**TSG-RAN Meeting #7  
Madrid, Spain, 13 - 15 March 2000**

**TSGRP#7(00)0104**

**Title: Agreed CRs to TS 25.427**

**Source: TSG-RAN WG3**

Figure 5: Outer loop power control information transfer

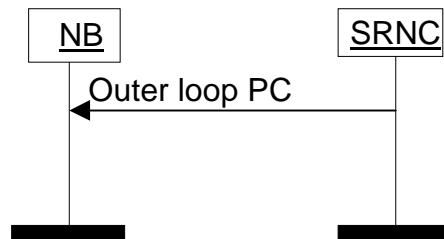
Based, for example, on the CRCI values and on the quality estimate in the UL frames, SRNC modifies the  ~~$E_b/N_0$  setpoint-SIR target~~ used by the ~~Node-B-UL Inner Loop Power Control~~ by including the absolute value of the new  ~~$E_b/N_0$  setpoint-SIR target~~ in one control frame sent to the Node B's. This control frame can be sent via any of the transport connections dedicated to one UE.

**Figure 17: Structure of the payload for outer loop PC control frame**

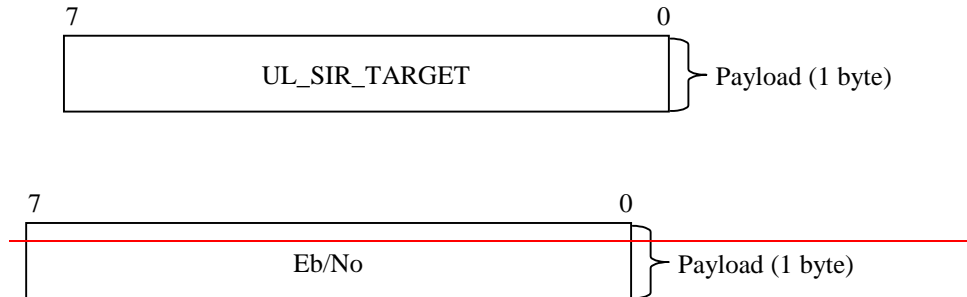
### 6.3.3.4.2 ~~Eb/No setpoint~~ SIR Target

**Description:** Value (in dB) of the ~~reference Eb/No SIR target~~ to be used ~~for~~ by the UL inner loop power control.

**Value range:** {~~0-8.2~~...~~25.5~~17.3 dB}, step 0.1 dB

SIR Target is given in the unit UL SIR TARGET where:

UL SIR TARGET = 000      SIR Target = -8.2 dB

UL SIR TARGET = 255      SIR Target = 17.3 dB

**Figure 1: Uplink data transfer**

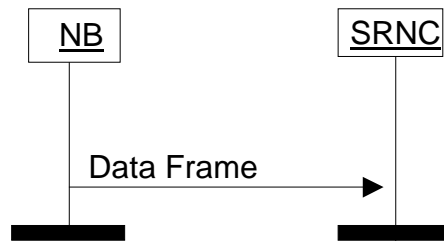
**Reason for change:** Clarification of the chapter 5.1.1 Uplink.  
In case Node B receives an invalid TFCI the UL data frames shall be handled in the same way as when the synchronisation is lost, data frames shall not be sent to the SRNC.

[When Node B receives an invalid TFCI no data frame shall be sent to the SRNC.](#)

Figure 8: DSCH TFCI Signalling

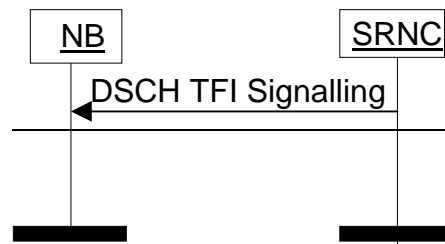
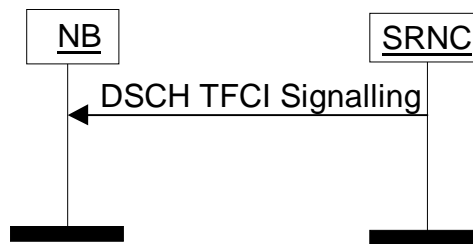
- The current specification is inconsistent in describing how multiple DSCH can be supported to the same user. In addition the mechanism by which the TFCI is built in the node B is not described.

This procedure is used in order to signal to the node B the TFCI (field 2) of the DSCH TBS to the Node B. This allows the node B to build the TFCI word(s) which have to be transmitted on the DPCCH, to use the combined TFCI codeword for the signalling of the DCHs and DSCH TFCIs in the radio frame.

The procedure consists in sending the DSCH TFCI signalling control frame from sent by the SRNC to the nNode B. The frame contains the DSCH-TFCI (field 2) and the correspondent CFN. The DSCH TFCI signalling frame is sent once every Uu frame interval (10 ms) for as long as there is DSCH data for that UE to be transmitted in the associated PDSCH Uu frame. In the event that the node B does not receive a DSCH TFCI signalling control frame then the node B shall infer that no DSCH data is to be transmitted to the UE on the associated PDSCH Uu frame and will build the TFCI word(s) accordingly.

Figure 21: [FDD - Structure of the payload for the DSCH DL signaling control frame]

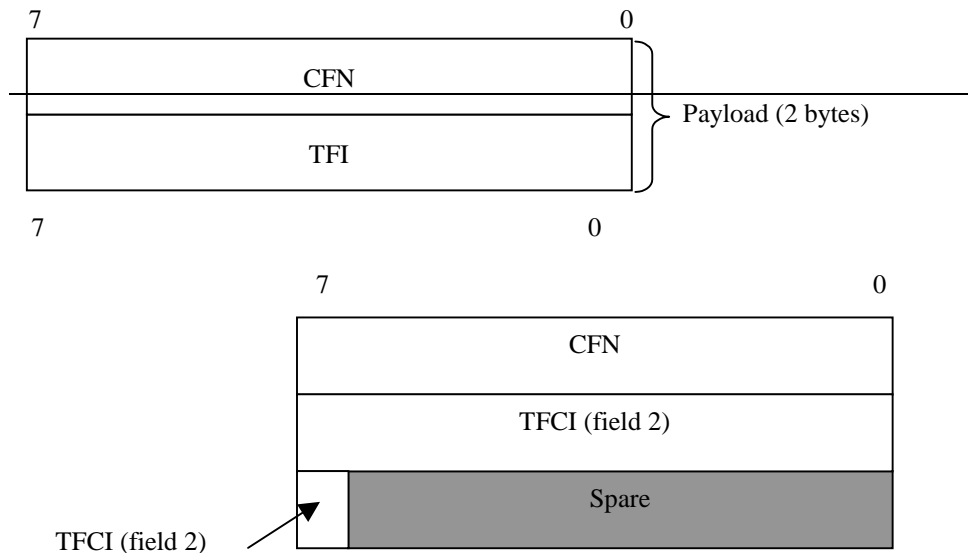
The figure below shows the structure of the payload when the control frame is used for signalling TFCI (field 2) bits. The TFCI (field 2) bits are used by the node B to create the TFCI word(s) for transmission on the DPCCH, used on the DSCH(s) of a user. A transport bearer of any DCH directed to this same user may be employed for transport over the Iub / Iur.

6.3.3.8.2 TFCI (field 2)

**Description:** TFCI (field 2) is as described in [4], it takes the same values as the TFCI(field 2) which is transmitted over the Uu interface.

**Value range:** {0 - 511}

**Field length:** 9 bits

Figure 11: Uplink data frame structure

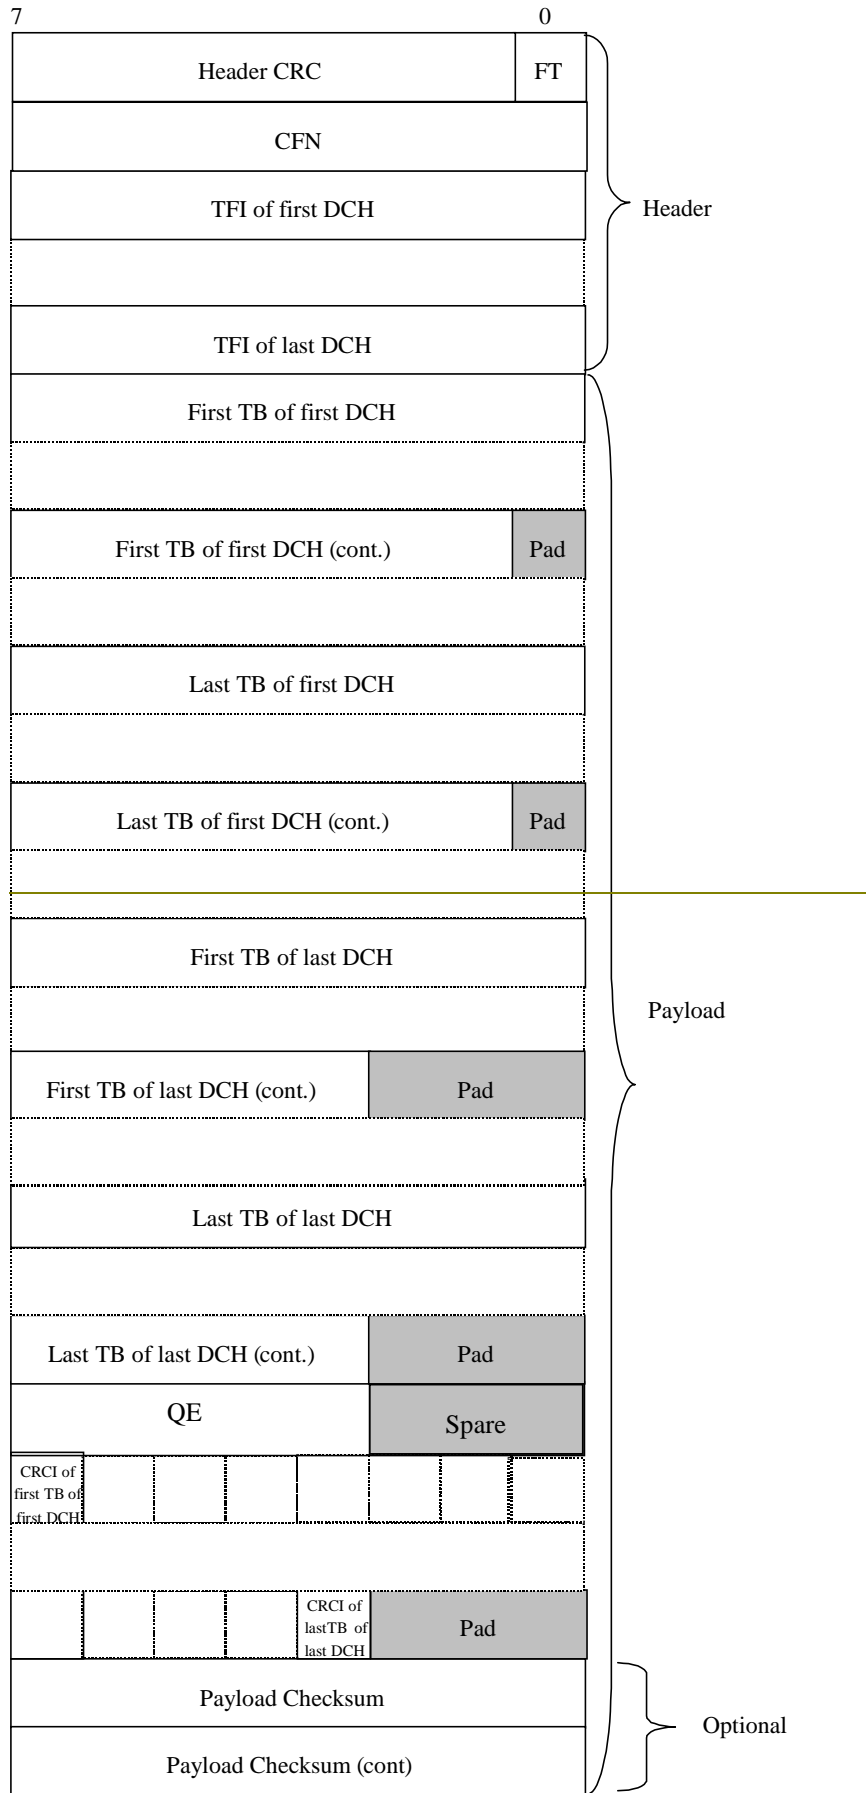
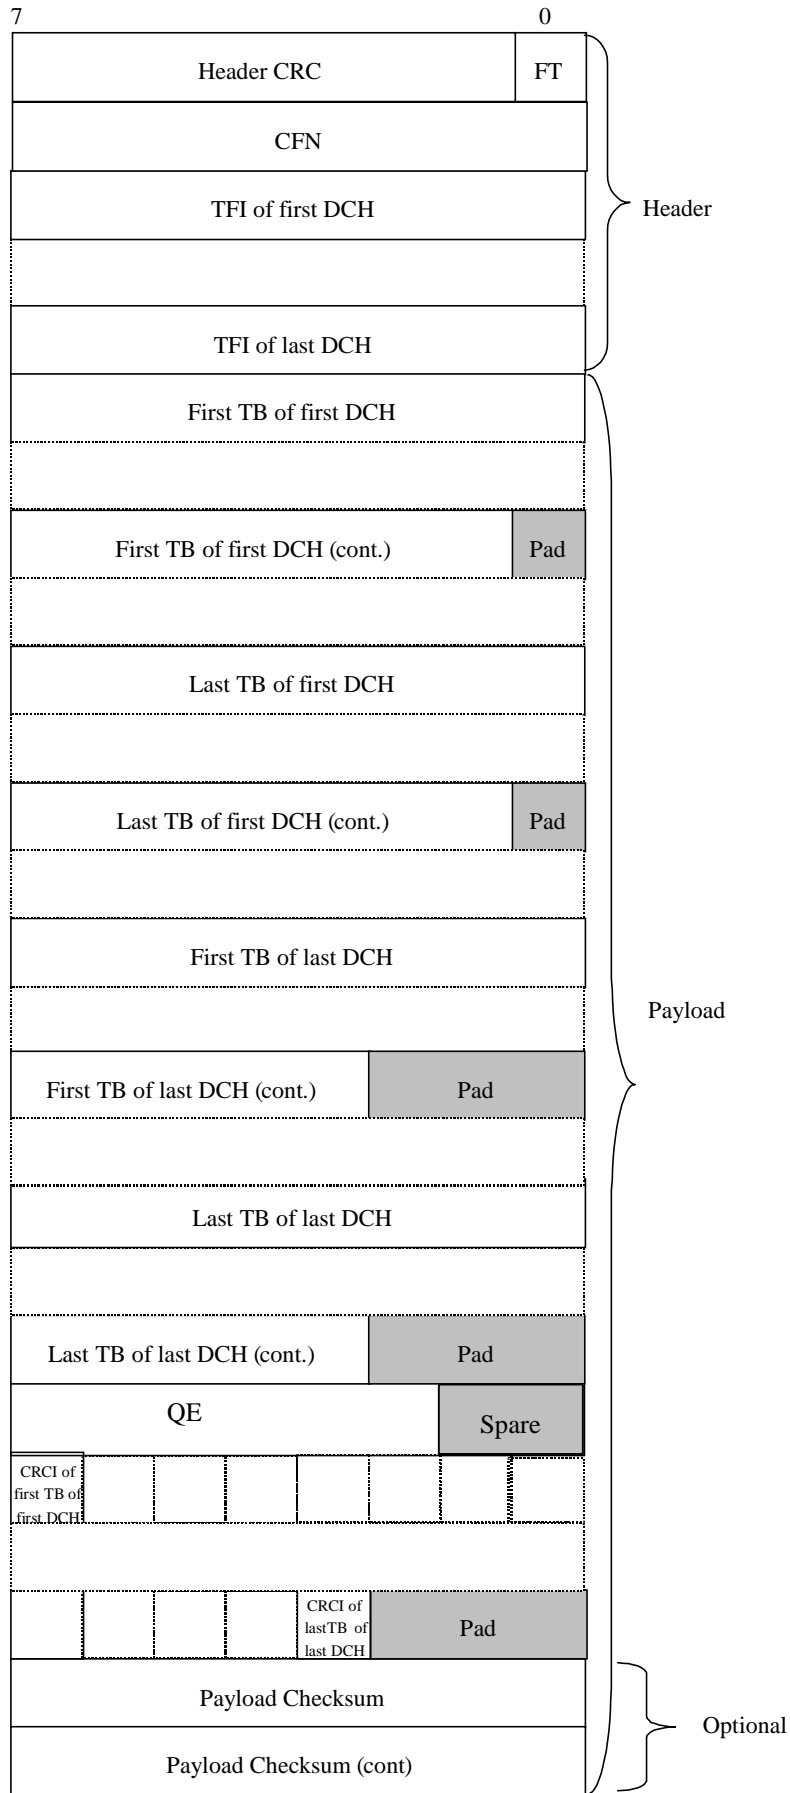
**Reason for change:**    Editorial comments on 25.427  
In the UL data frame the number of bits for the QE is corrected.

**Figure 20: Structure of the payload for Rx timing deviation control frame**

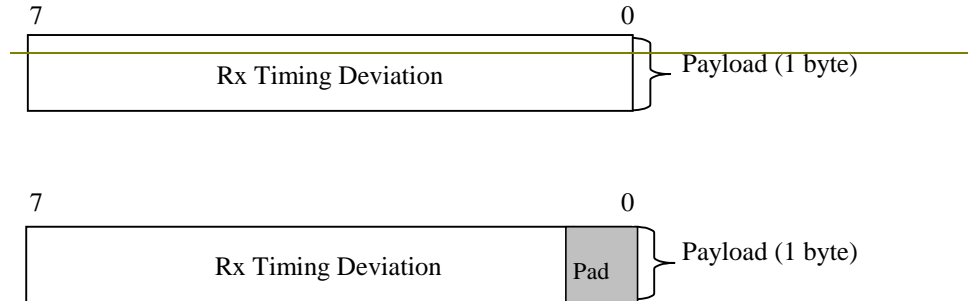
**Value range:** { -512-256, ..., +508-256 } chips, ~~step 4 chips~~.

**Field length:** ~~8~~ 7 bits

$\{N*4 - 256\} \text{ chips} \leq \text{RxTiming Deviation} < \{(N+1)*4 - 256\} \text{ chips}$

With  $N = 0, 1, \dots, 127$

**Granularity:** 4 chips

Figure 9: Radio Interface Parameter Update

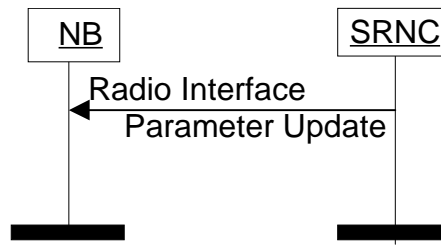
This CR proposes a new DL user-plane control frame which can be used to change radio interface related parameters for dedicated RL's.

This procedure is used to update radio interface parameters which are applicable to all RL's for the concerning UE. Both synchronised and unsynchronised parameter updates are supported.

The procedure consists of a Radio Interface Parameter Update control frame sent by the SRNC to the Node B.

If the Radio Interface Parameter Update control frame contains a TPC Power Offset value, the Node B shall apply the newly provided TPC PO as soon as possible in case no CFN is included or from the indicated CFN.

**Figure 22: Structure of the payload for the Radio Interface Parameter Update control frame**

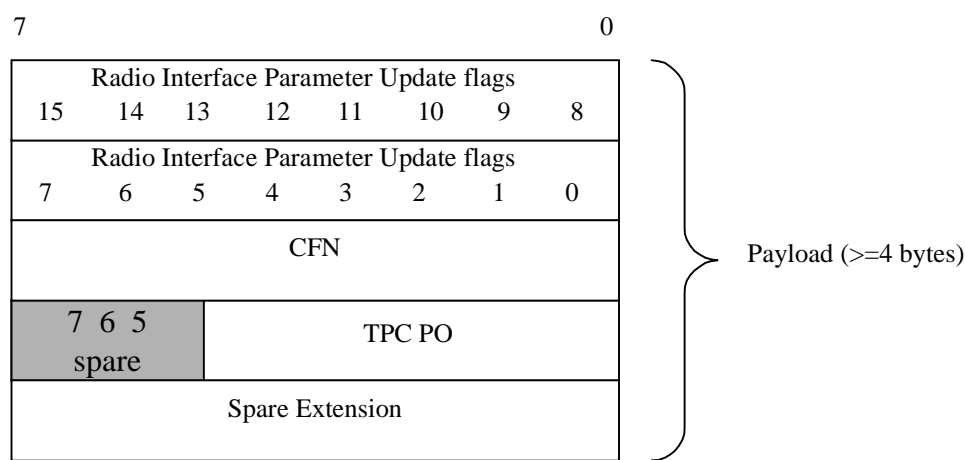
The figure below shows the structure of the payload when the control frame is used for signalling radio interface parameter updates.

**Bit 2-15:** Set to (0); reserved in this user plane revision. Any indicated flags shall be ignored by the receiver. **Field length:** 16 bits

**Figure 10: Example of notation used for the definition of the frame structure.**

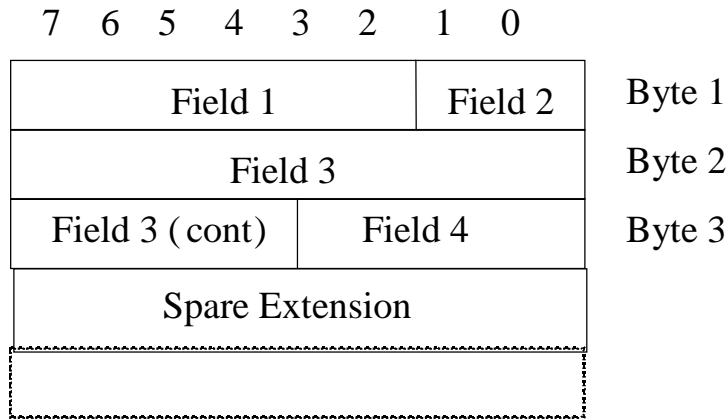
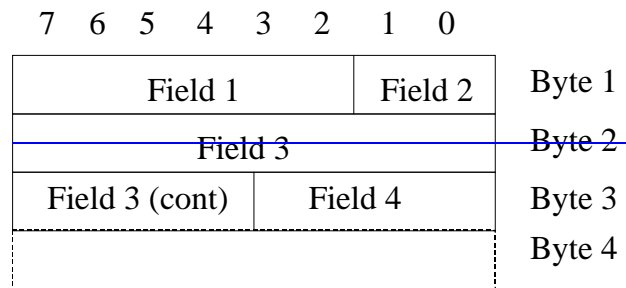
**Reason for change:** To enable backward compatible additions and changes this CR proposes to include a Spare Extension into Data and Control frames of Iub/Iur User Plane DCH Protocol.

Bits labelled "Spare" shall be set to zero by the transmitter and shall be ignored by the receiver. The Spare Extension indicates the location where new IEs can in the future be added in a backward compatible way. The Spare Extension shall not be used by the transmitter and shall be ignored by the receiver.
